Fletcher Stream and Wetland Mitigation Site

Annual Monitoring Report

Monitoring Year 2 of 7

Subject: MY2 Monitoring Report
Fletcher Stream and Wetland Site, Henderson County
French Broad River CU 06010105
DMS Project ID No. 100004 / DEQ Contract #006997

XS Number: 22

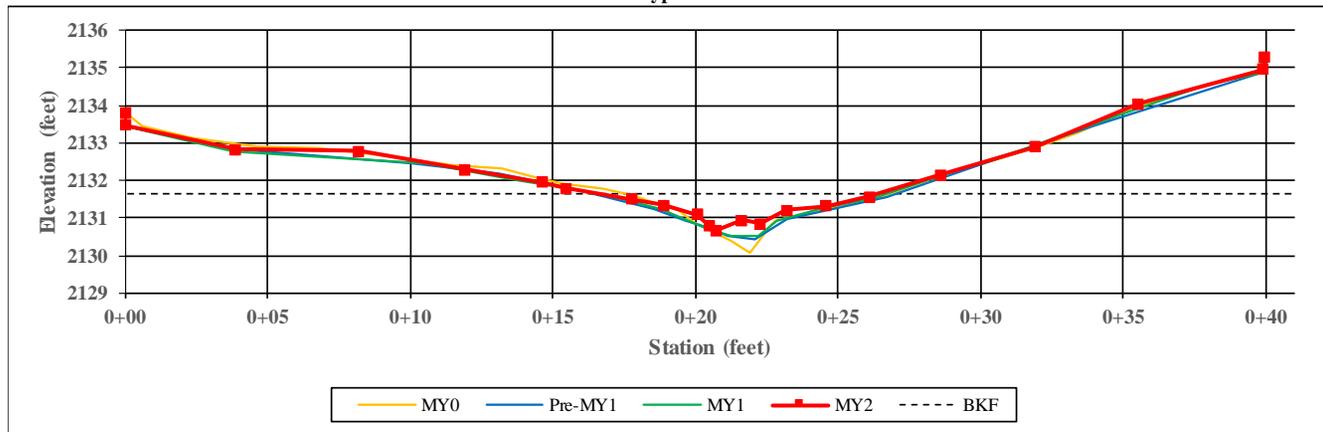
- For Table 6, the submitted spatial data representing the low stem density areas have a combined acreage of 0.09 ac, not 0.9 acres. Also, please be sure to report the cumulative total and include the encroachment area in this table. Please also provide a brief description of the encroachment so it can be characterized in the DMS geodatabase. **Edited table. A description of the type of encroachment is available in the attribute table. (Mowing along easement boundary and area mistakenly cleared by adjacent property owner)**
- For the BHR calculations, be sure that Omit Bkf boxes are selected based on the Low Bank Height elevation (LBH). For example, cross section 6 excludes points (23.15, 2106.380) and (37.17, 2106.264), but these should be included given that the LBH elevation is 2106.65. As another

example, cross section 22 does not omit points (17.79, 2131.489), (18.88, 2131.333), (24.56, 2131.314), and (26.10, 2131.556), but the LBH is 2131.21. **Cross-section data reviewed and edited.**

Gauge ID: **MW7**
 Total Number of Consecutive Days Water Table within 12 inches of Soil Surface: **9**
 Percentage of Growing Season Water Table within 12 inches of Soil Surface: **4%**

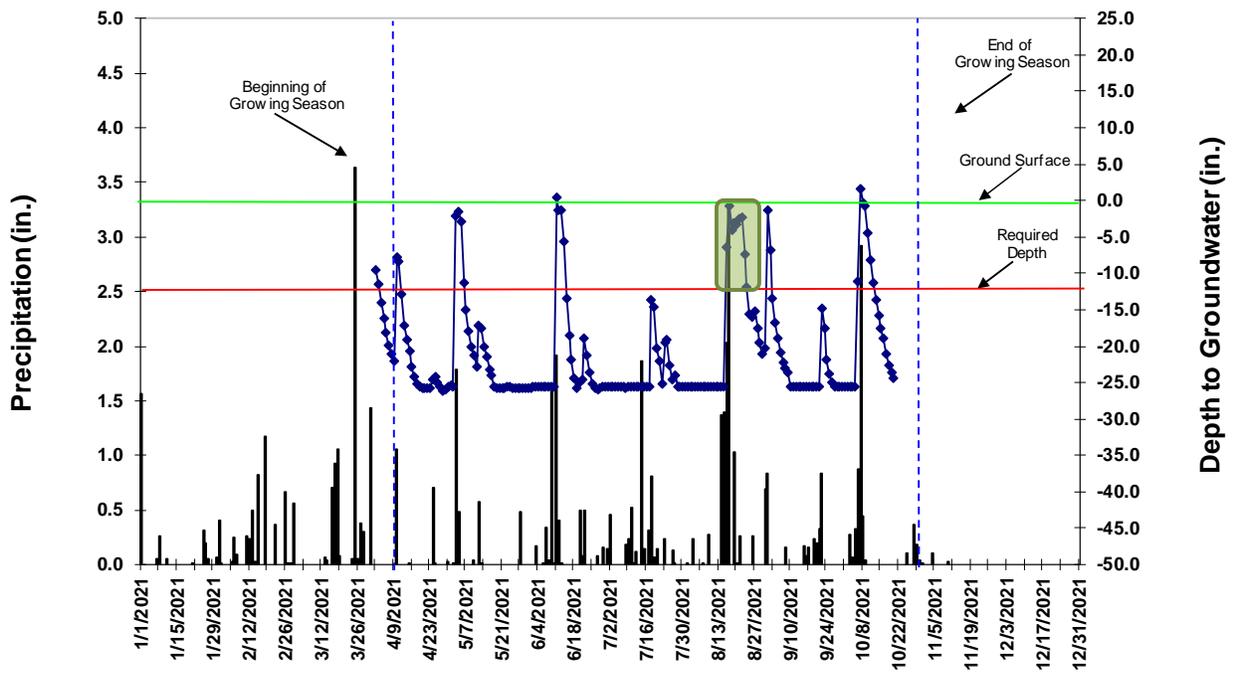
- The figure for MW7 highlights an area where the water level drops below the required depth. **Replaced with corrected highlight.**
- Please submit a feature characterizing the treated invasive areas. **Included in the MY2 database.**
- Please include the crest gauge photos in the report. **Crest Gauges were depicted in the photos associated with cross-sections 1, 11, 15, and 26 in the report. Individual photos of the four Crest Gauges have been added to the Photopoints section of the report and in the support files.**
